ADDENDUM NO. 4
to
PROJECT MANUAL
for

New Castle Avenue Roadway from Marcy Street to the Bridge over Piscataqua River Inlet and
Seawall Project
Bid Proposal #26-06
PORTSMOUTH, NEW HAMPSHIRE

NOTICE TO ALL BIDDERS

SKETCH SK-1A

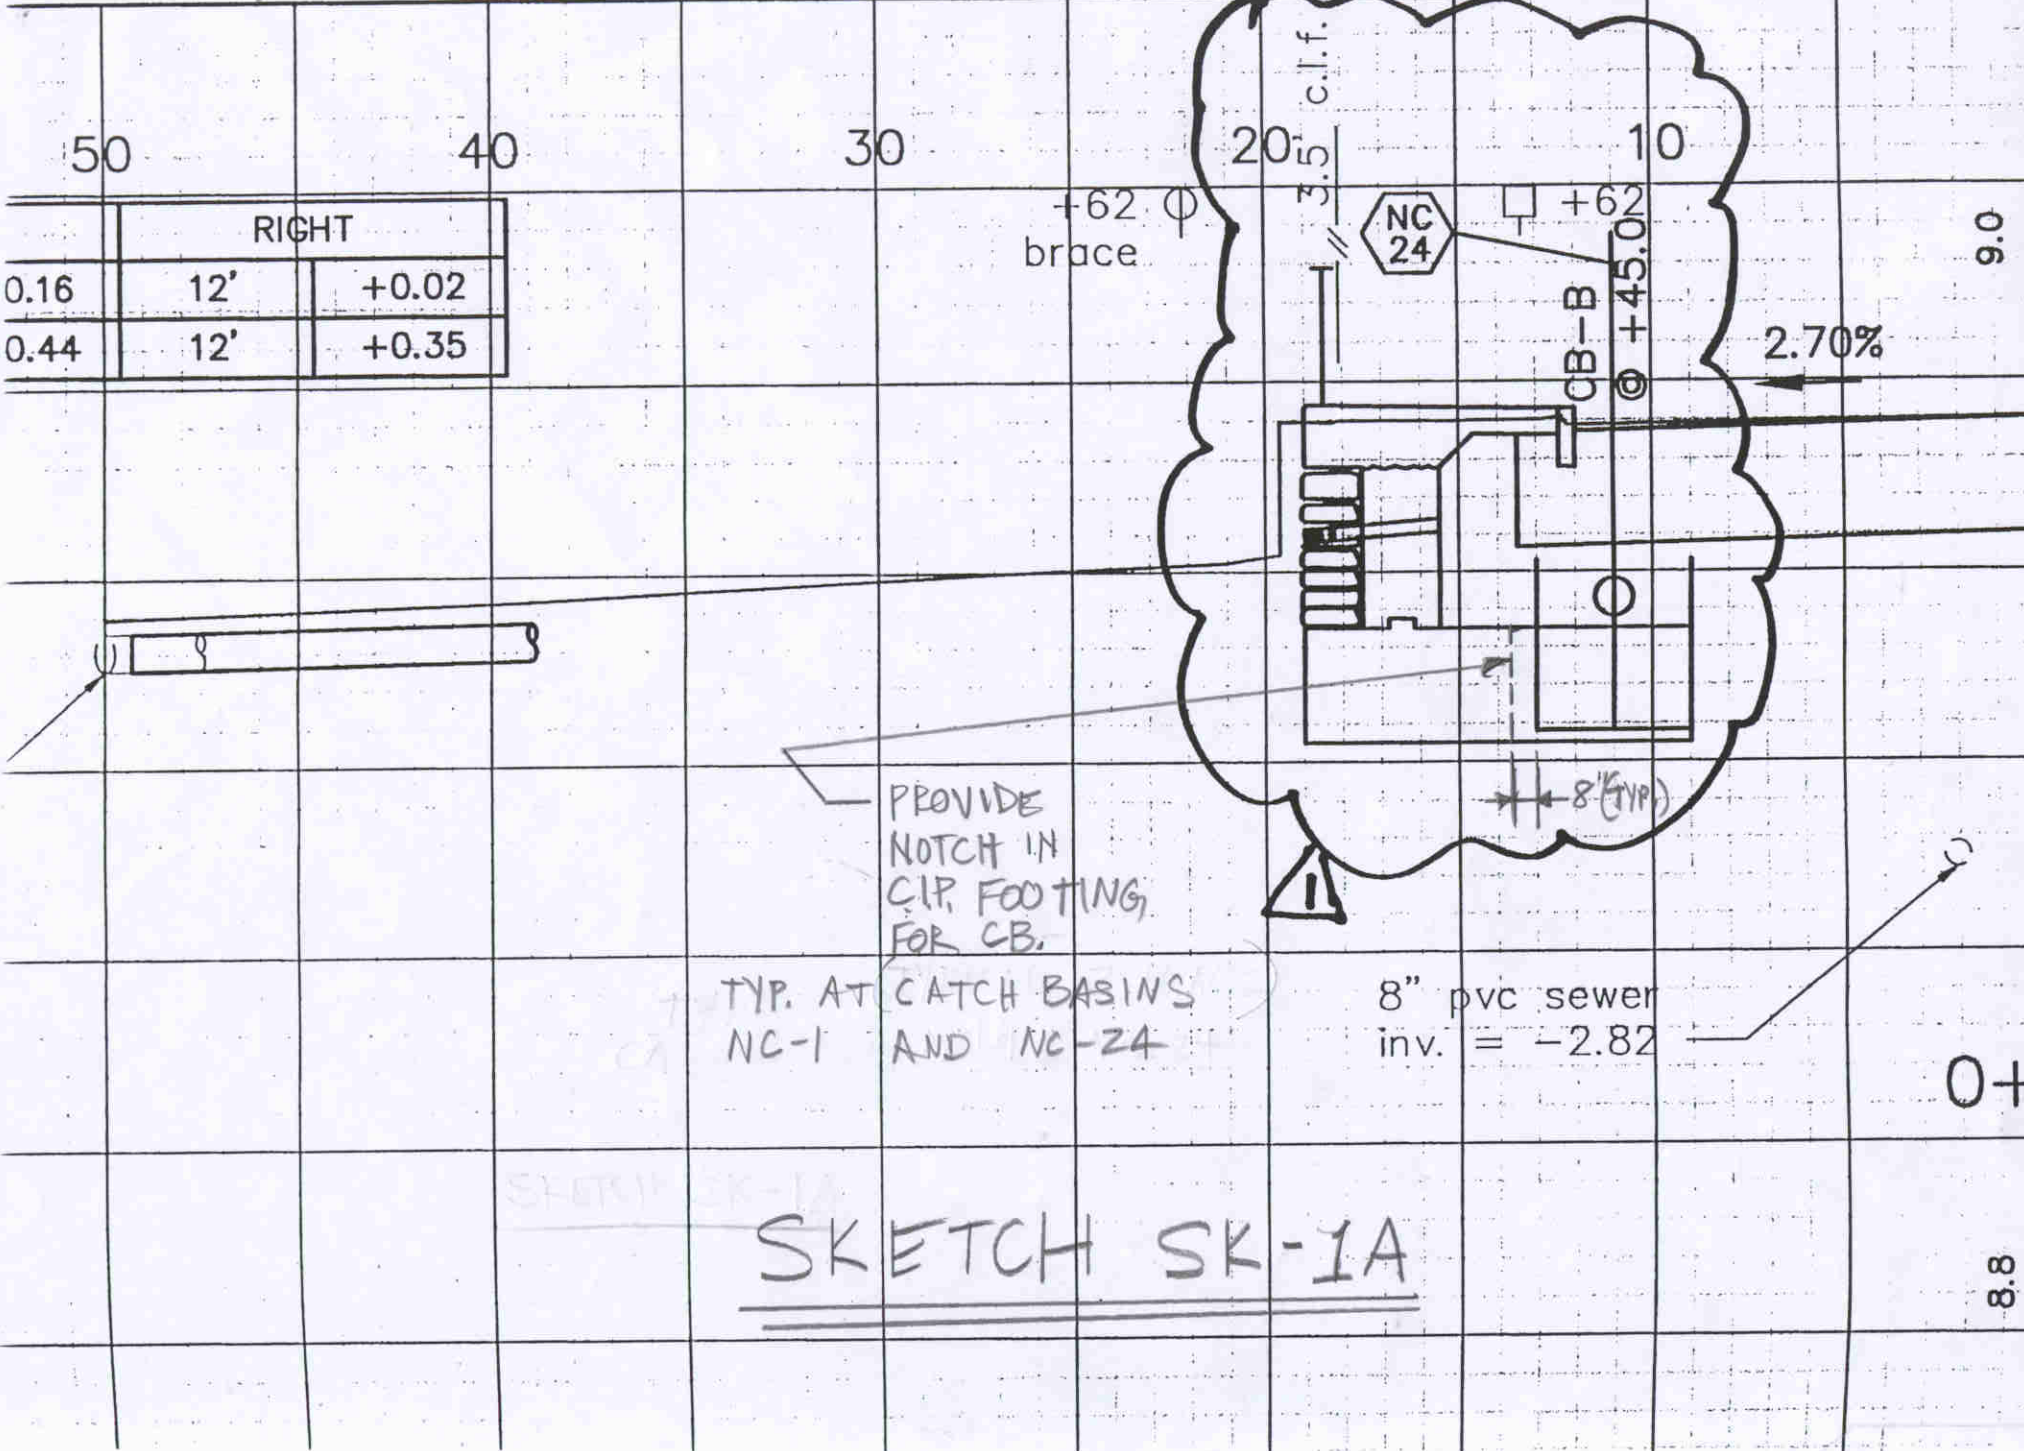
- 1.1.2.9 The contractor shall coordinate the detailing and installation of the cast-in-place concrete seawall footing with the pre-cast concrete drainage catch basins to be installed along the curb line of Newcastle Avenue. The seawall footing shall be notched or recessed in the manner indicated below:
- 1.1.2.9.1 Modifications to the cast-in-place seawall footing shall be made to provide a footing notch for the following drainage catch basins:

NC-1
NC-24

See Sketch SK-1A and SK-1B.

The seawall footing shall be constructed with a full-depth notch that is 8" wider than the outside of the catch basin in each direction as shown on SK-1A and SK-

1B. Seawall footing face reinforcing shall be provided on all sides of the footing notch, and 4'-0" long #6 corner bars shall be provided at the top and bottom of all interior corners of footing notches. Contractor shall backfill the space between the catch basin and the seawall footing with crushed stone. Contractor shall coordinate the catch basin dimensions and seawall footing reinforcing details as required and indicate such on all related shop drawing submittals.

SKETCH SK-2

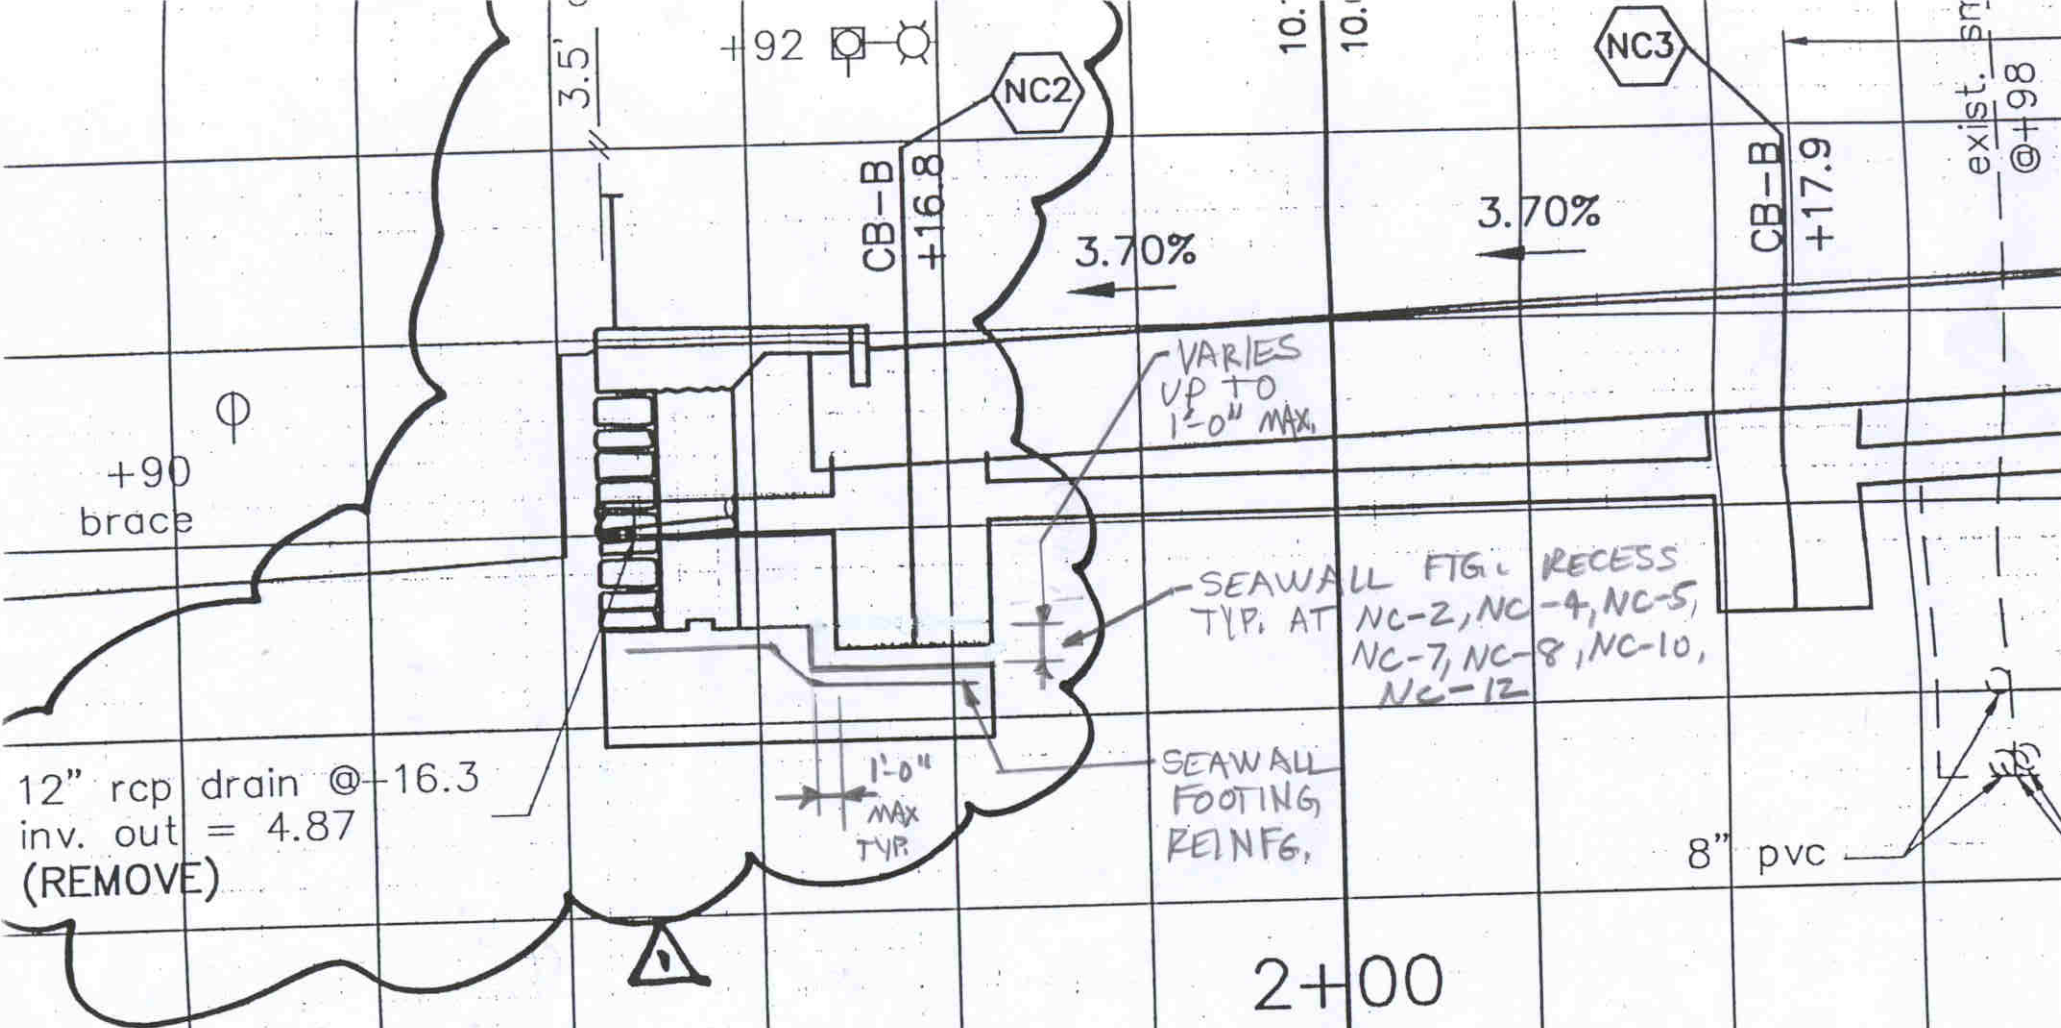
1.1.2.9.2 Modifications to the cast-in-place seawall footing shall be made to provide a footing recess for the following drainage catch basins:

NC-2
NC-4
NC-5
NC-7
NC-8
NC-10
NC-12

See Sketch SK-2.

The seawall footing shall be constructed with a locally recessed area that is 1'-0" wider than the outside of the catch basin in each direction as shown on SK-2. The top of the seawall footing shall be recessed only as deep as needed up to a maximum depth of 1'-0" to create clearance for the installation of the catch basin. The seawall footing reinforcing steel shall be bent down at 45 degrees to maintain cover. The catch basin sump dimension from the invert of the lowest pipe may be reduced by up to 6" (diminishing the overall depth of the catch basin) to provide additional adjustment if needed. The contractor may install up to a 2" thick compacted sand bed on top of the concrete seawall footing for elevation adjustment and leveling of the catch basin base if needed. Contractor shall backfill any space between the catch basin and the seawall footing with crushed stone. Contractor shall coordinate the catch basin dimensions and seawall footing reinforcing details as required and indicate such on all related shop drawing submittals.
